MCPB No. 20-118
Sketch Plan No. 320200060
4725 Cheltenham Drive
Date of Hearing: November 5, 2020

RESOLUTION

RE: Sketch Plan No. 32020006A
Site Plan No. 820220060
4725 Cheltenham Drive

TO: Marie LaBaw, PhD, PE
FROM: Timothy Hoffman, PE
CC:
DATE: January 18, 2022
SUBJECT: 4725 Cheltenham, 32020006A / 820220060
Fire Department Access Plan Amendment, Scope of Work Letter

Fire Department Access Review

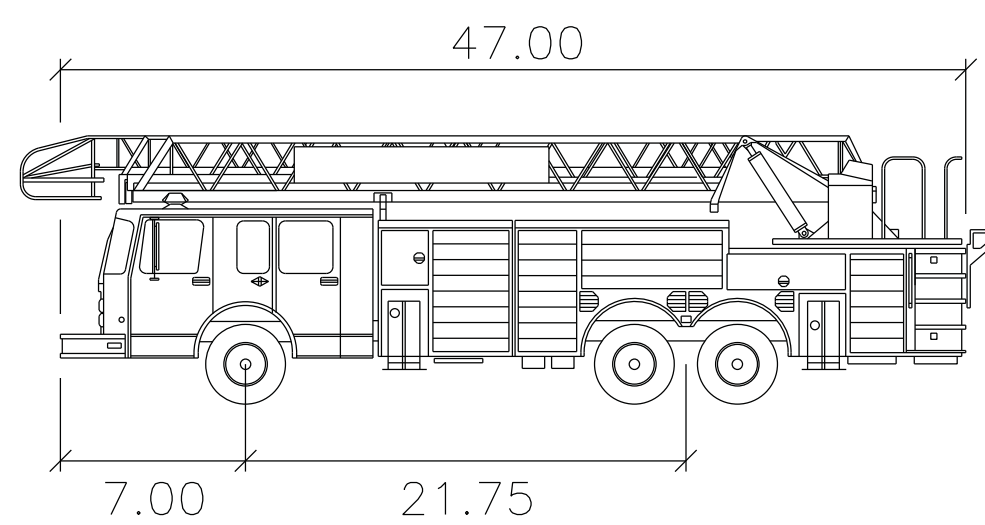
The scope of work of this Amendment is the revised location of the second Fire Department Connection (FDC) from the front right corner (southeast) on the building facing Cheltenham Drive to the same corner of the building but now facing the adjacent public alley. Additionally the FDAP shows the revised public bike lane per M-NCPPC/MCDOT changes which includes moving the fire hydrant from the behind the curb to be located on the bike lane median adjacent to the Fire Lane. Both the existing and proposed hydrants are within 7' of the Fire Lane. The separation between the two FDC's meets the required distance.

BY: SAC FM: 43 DATE: 1/18/2022
original 9/21/2021
